COUNCIL ASSESSMENT REPORT
SYDNEY NORTH PLANNING PANEL

SNPP No	PPSSNH-500
DA Number	LDA2024/0092
Local Government Area	City of Ryde
Proposed Development	Demolition of existing structures and construction of a mixed-use development comprising retail premises, 411 residential apartments, basement parking for 1,135 vehicles and stratum subdivision into six lots. The application is integrated development pursuant to: Section 91 of the Water Management Act 2000. Section 138 of the Roads Act 1993.
Street Address	152-190 Rowe Street and 3-5 Rutledge Street, Eastwood.
Applicant/Owner	The Trustee for Eastwood Centre Unit Trust
Date of Lodgement	13 May 2024
Number of Submissions	<u>First Notification</u> 18 unique submissions by way of objection. <u>Second Notification</u> 18 unique submissions by way of objection.
Recommendation	Approval subject to conditions
Regionally Significant Development Criteria (Schedule 6 of SEPP (Planning Systems) 2021)	General Development over \$30 Million. Cost of works: \$338,392,607 (excluding GST)

<ul style="list-style-type: none"> • Ryde Development Control Plan 2014; and • Section 7.11 Contribution Plan.
Clause 4.6 Requests	<ul style="list-style-type: none

Figure 33 – Building Separation – Building A – Levels 9 and 10

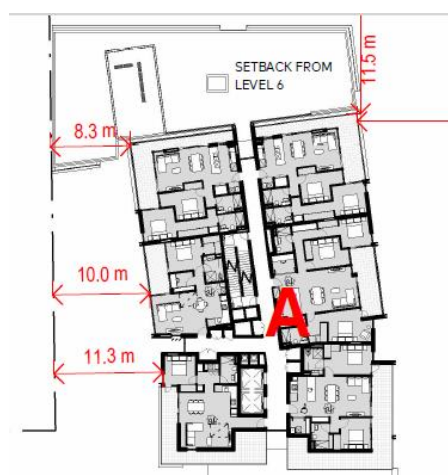
Building A provides an 8.3m-11.3m separation to the western side boundary at Levels 9 to 10 where the ADG requires 12m at Level 9 and above (Refer to **Figure 33** below).

The building separation is considered satisfactory as it is a minor part of the overall development which is otherwise compliant.

Figure 34 – 2B02 and 2B03 Apartment Layouts.

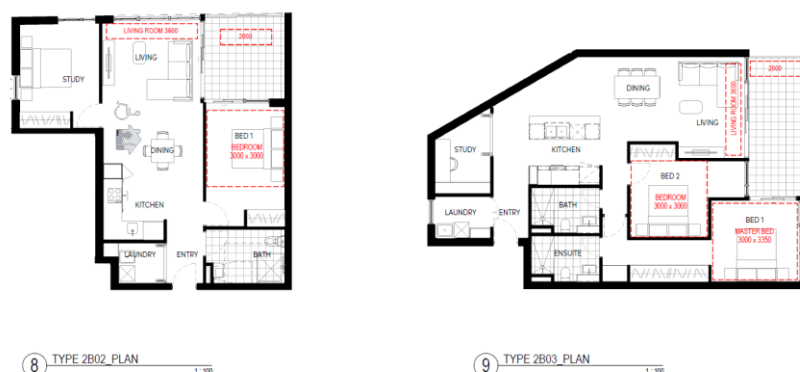
The apartment layout for Type 2B02 and 2B03 units provide a 3.8m living room width where the ADG specifies 4.0m (**Figure 34**).

The apartment layouts demonstrate adequate internal amenity including adequate space for furniture and circulation.

Figure 36 – RLEP Height of Buildings Map.

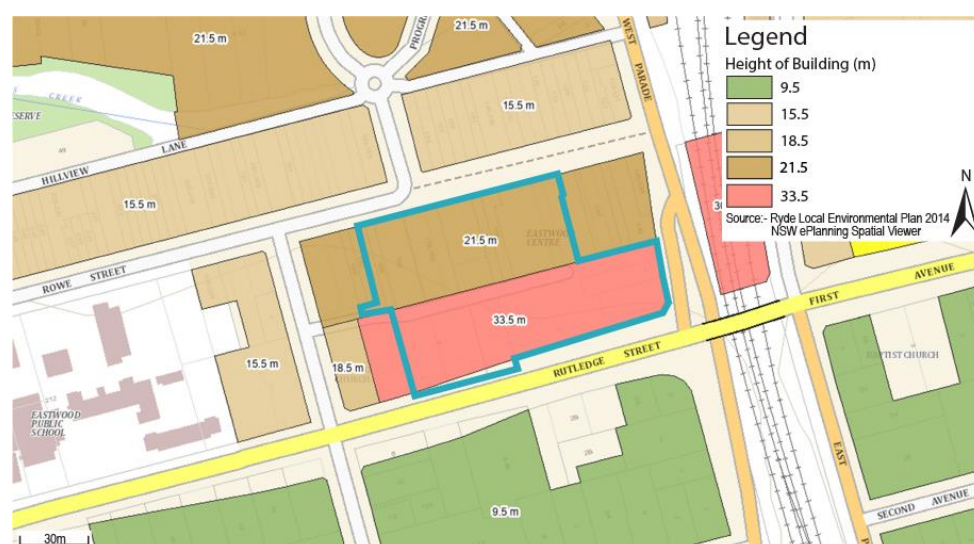
The site is mapped as having a maximum building height of 21.5m adjoining Rowe Street Mall and 33.5m adjoining Rutledge Street as shown in **Figure 36** below.

The proposal does not comply with the development standard in Part 4 of the LEP, Clause 4.3 'Height of Buildings' and accordingly, a Clause 4.6 request has been provided with the application for the exceedance of the maximum height of building standard.

Figure 45 – Setback Variation Diagram.

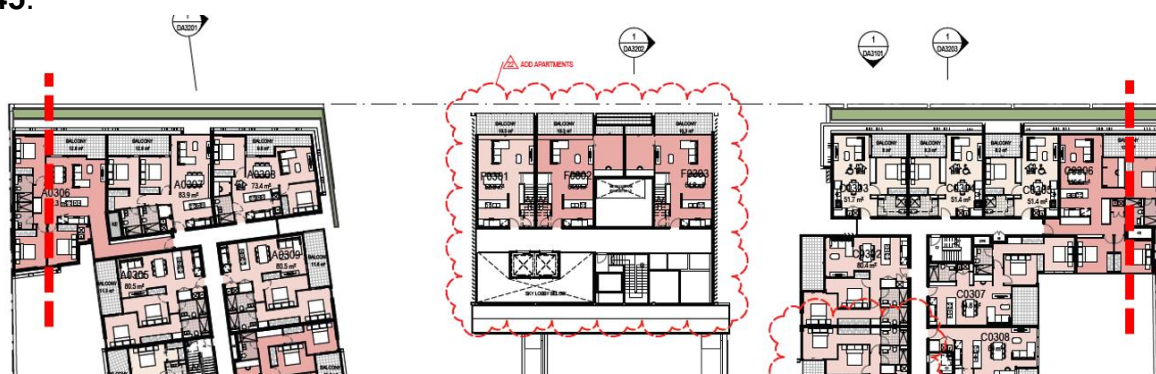
Clause 3.3.1(e) requires a 3m setback to all boundaries, where the building exceeds 9.5m in height from the street level.

The development proposes a nil setback to the eastern and western ends of the Rowe Street Mall frontage in lieu of a 3m setback as shown by the red dashed line in **Figure 45**.

Minor variations are also proposed to the Rutledge Street and West Parade front setback due to a non-linear boundary line.

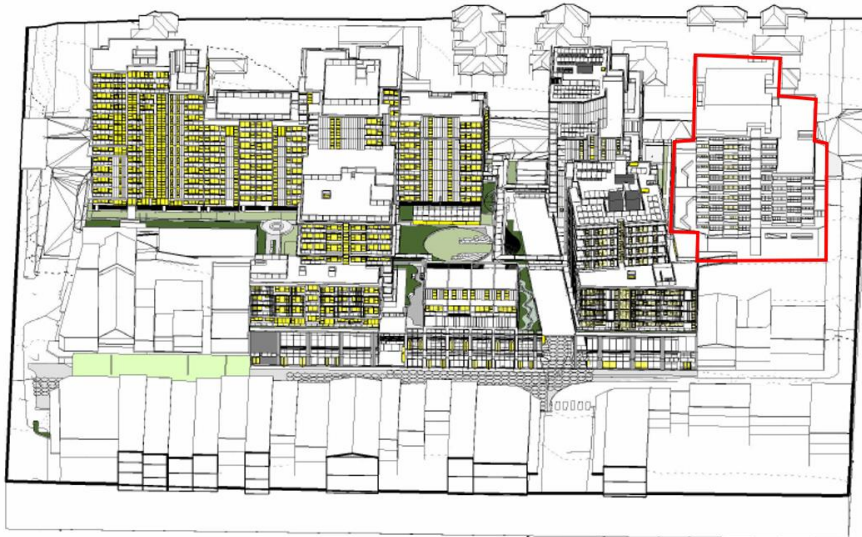
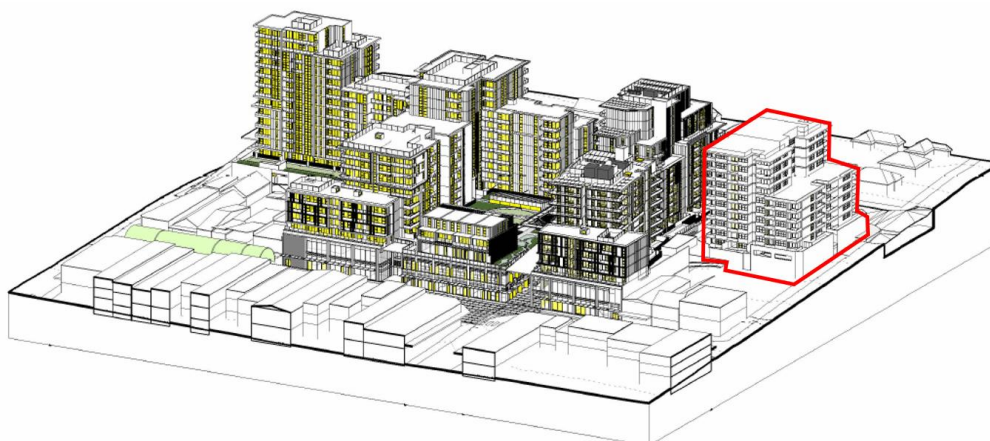
The overshadowing of No. 7 Rutledge Street, Eastwood, by the proposed development, between 9am and 3pm mid-winter is detailed in the eye of the sun diagrams in **Figure 47** to **Figure 53** (No. 7 Rutledge Street is outlined in red).

The principal impact is to the eastern elevation of No. 7 Rutledge Street between 9am and 12pm mid-winter.

Figure 55 – LEP and Proposed Solar Access to Eastern Elevation of No. 7 Rutledge Street.

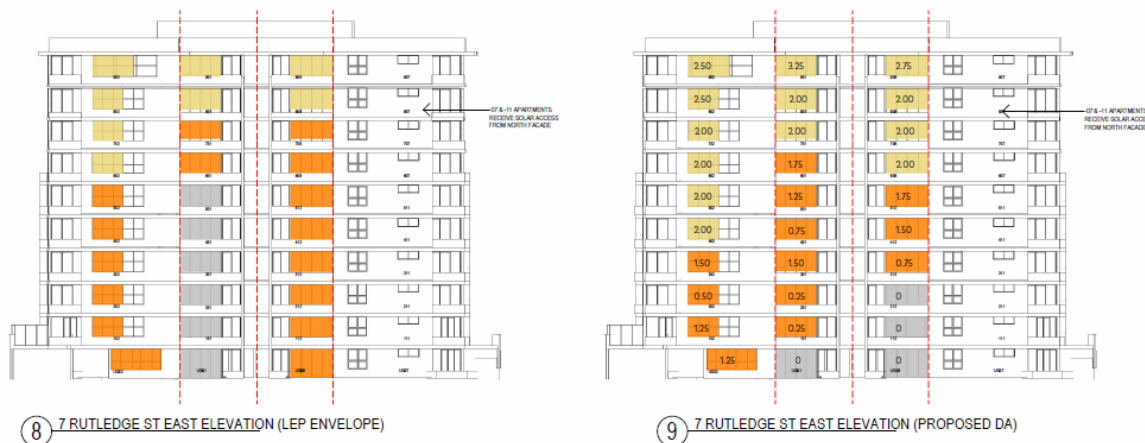
An excerpt of the comparative solar analysis between the maximum permissible LEP envelope and the proposed development is provided in **Figure 55**.

The above analysis demonstrates the proposed development provides no less solar access than the previously approved DA and when compared to a compliant LEP building envelope.

Figure 56 – Section – Interface Between RFB on No. 7 Rutledge Street and Proposed Building B

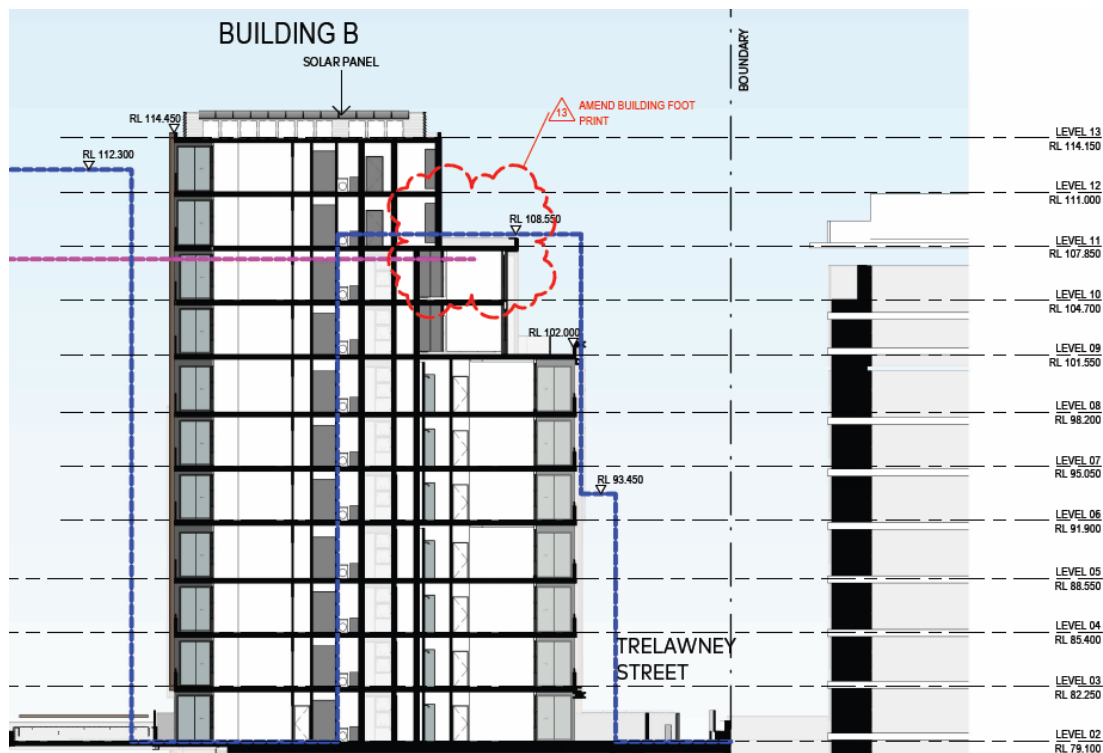
No. 7 Rutledge Street is set back 6m from the common boundary for all 10 storeys. The proposed development is set back between 9m to 13.4m from the common boundary as shown in **Figure 56**.

There is no requirement under Part 3F of the ADG to provide for additional building separation where an adjoining site is non-compliant. Notwithstanding, the proposed development provides privacy screens to Levels 6 to 8 to improve the visual privacy afforded to No. 7 Rutledge Street.

Further, the proposed development limits the number of apartments at Level 9 and above with an interface to No. 7 Rutledge Street to either one or two.

Figure 57 – Originally Submitted (Left) and Amended (Right) Level 12 Plan.

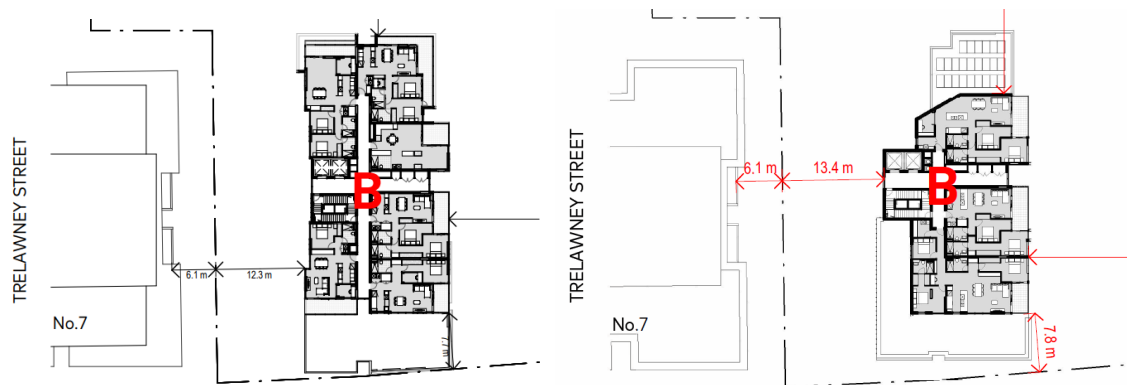
For example, the Level 11-12 building setback was increased from 12.3m to 13.4m and the floorplate of those levels substantially reduced as shown in **Figure 57**.

For the reasons given above, the building separation is considered satisfactory and accordingly visual privacy concerns raised in the submissions does not warrant refusal of the DA.

Figure 58 – Proposed Non-Trafficable Zone.

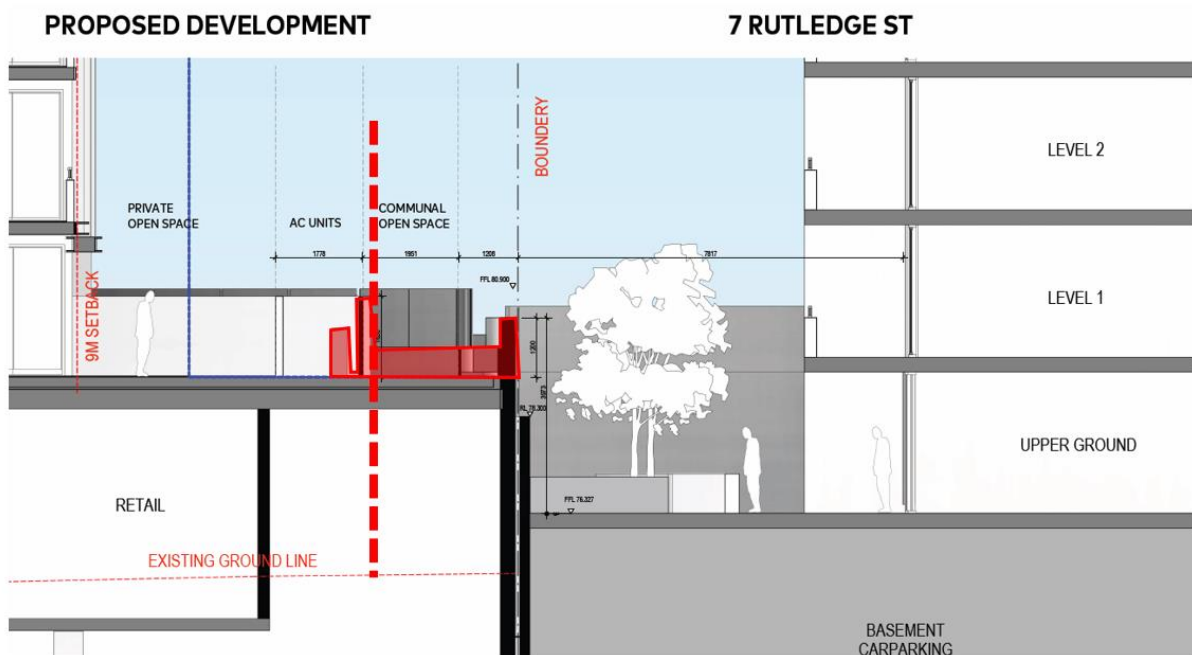
The reduced height non-trafficable zone is shown in **Figure 58**.

The amendments require deletion of the outer balustrade to better align with the wall on No. 7 Rutledge Street and creation of a 3m wide non trafficable zone (dashed red line).
